**Subject: LQD Permit 478
Willow Creek Project
Annual Report for WYDEQ Permit to Mine No. 478**

WDEQ/LQD Comments 2014 Annual Report

**ANNUAL REPORT
PERMIT TO MINE NO. 478
July 1, 2013 through June 30, 2014**

Temporary Cap Well Removal Completion
Logs With Shallow Groundwater Monitoring
Completion Logs

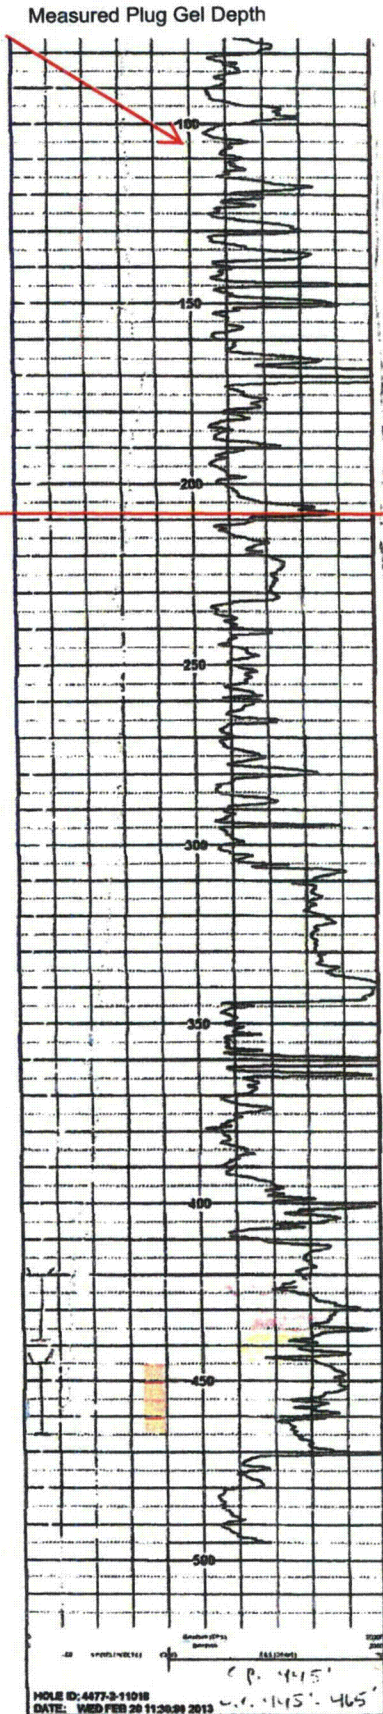
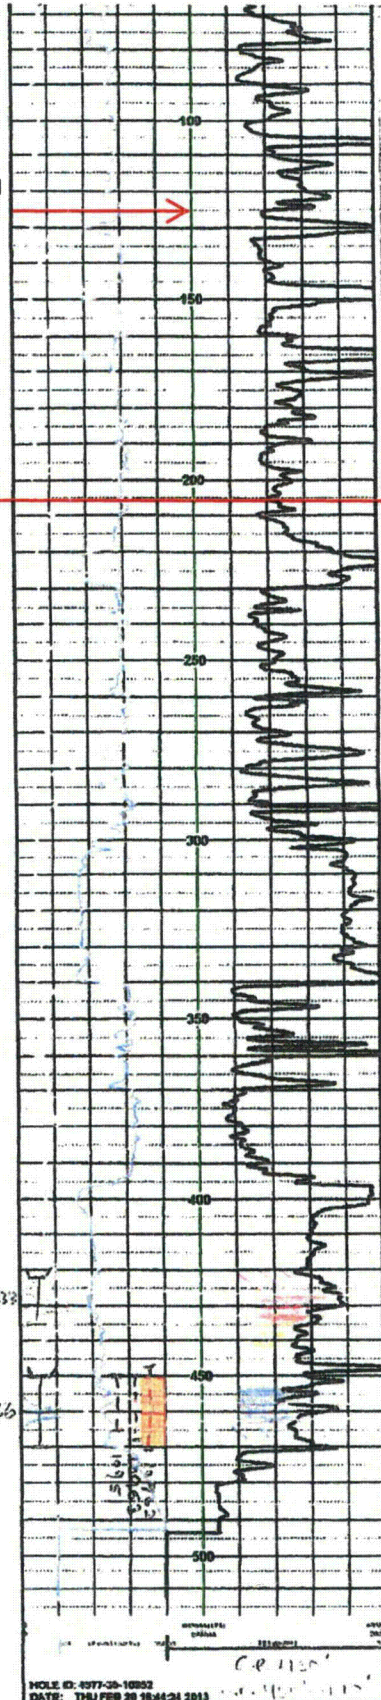
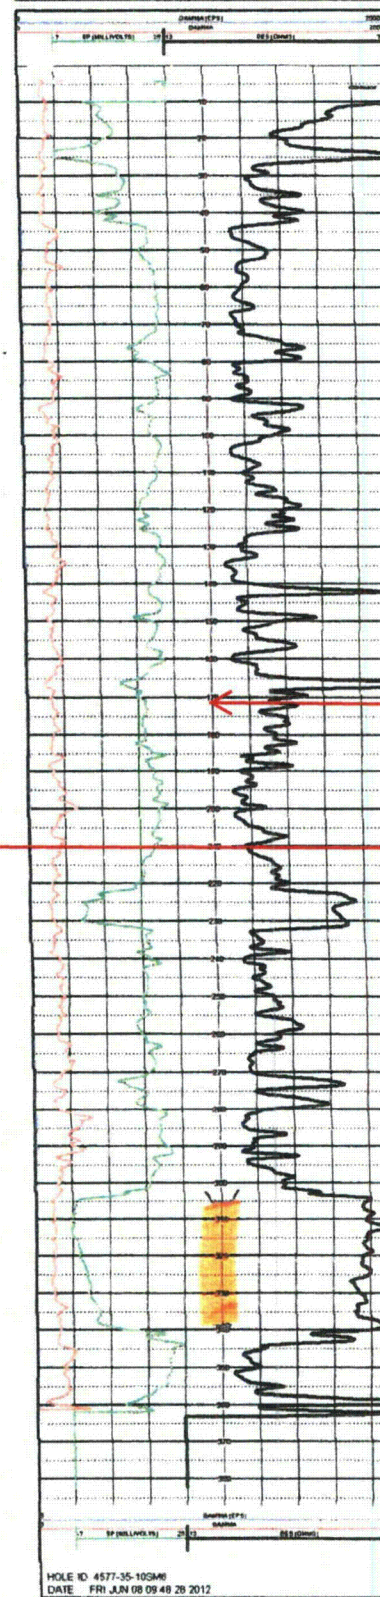
11. Worksheet #5, Well Plugging and Abandonment; it does not appear that bonding has been included for plugging of the 200 temporarily capped pilot holes in Mine Unit 10B, Modules 10-7 and 10-8. Please update the Surety Estimate accordingly to account for this work or indicate where this cost is accounted for in the bond estimate.

On April 13 2015 Uranium One removed two temporary foam caps at wells 10952 and 11018 as shown on the attached map (see Attachment 1). These wells were chosen based on the proximity to shallow groundwater monitoring locations. Plug gel was encountered at 125.5 feet from the surface for 10952 and 105 feet for 11018. Comparing these values to the completion logs, both these wells are 50 feet above the uppermost saturated strata. Per LQD Rules and Regulations Chapter 8 if the column or the sealant material has dropped or fallen back, the discoverer shall continue to install sealant material until the top of the sealant material column remains at least 50 feet above the top of the uppermost saturated groundwater stratum; and users will install uncontaminated fill material, drill cuttings or one of the approved sealant materials listed herein from the top of the sealant material column to within approximately 5 feet of the ground surface. Uranium One plans to adhere to these regulations and fill the column with approved material to 5 feet from the ground surface. This is allowed due to the fact that the plug gel is 50 feet above the uppermost saturated groundwater stratum. Refer to Appendix 2 which shows the completion logs of the two shallow ground water wells that are close to the two wells in which were opened.

The 200 temporarily capped pilot holes were filled with plug gel prior to placement of the temporary caps. The only cost that is currently not accounted for in the cost for abandonment of these holes is the cost for a cement cone/marker which accounts for \$2000 in costs.
